Scientific Analysis/Calculation Administrative Change Notice

1. Document Number:	ANL-WIS-MD-000027	2. Revision:	00	3. ACN:	01
4. Title:	Features, Events, and Processes for the Total System Performance Assessment: Analyses				
5. No. of Pages Attached:	48

Figure I-3a. Plan View of the UZ Flow Model Domain for Site Recommendation Showing Nearby Faults and Boreholes

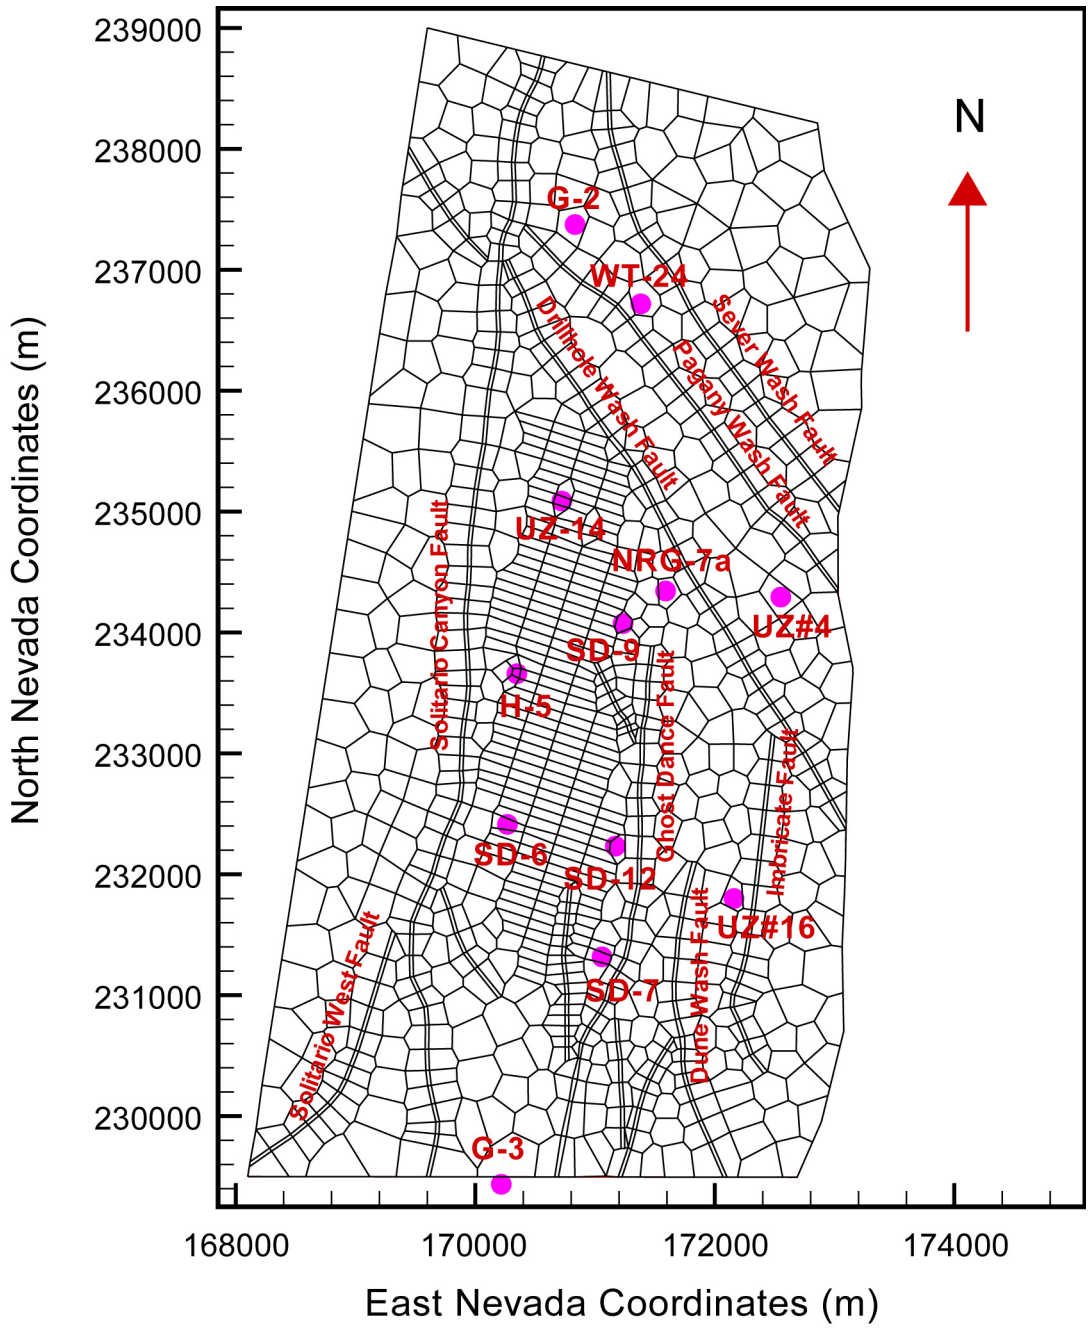
8-41	Updated referencing information for NEA 2006 [DIRS 185174].
8-55	Updated referencing information for SNL 2008 [DIRS 183478].
8-76, C-4, E-2, E-9	Direct input usages of DTN: MO0703PASEISDA.002 [DIRS 183156] are corrected to the information actually utilized from a revised version in DTN: MO0703PASEISDA.002 [DIRS 185278] (CR 11873).
A-2	Table A-1, Control Parameter 01-03, is clarified by noting that FEP 1.1.01.01.0A is excluded.
A-14	Control Parameter 07-03 has been removed as it is no longer in use.
C-3, C-5, C-6, C-16, C-18	Indirect input DTN: MO0703PASEISDA.002 [DIRS 183156] updated to the revised version this DTN: MO0703PASEISDA.002 [DIRS 185278] (CR 11873). These page changes are not included as they only affect the DIRS number presented for this source.
E-8	Source information was included for the variable f_b.
I-11	Figure I-3a is replaced by original source figure, which is more consistent with figure caption and its comparison Figure I-3b.
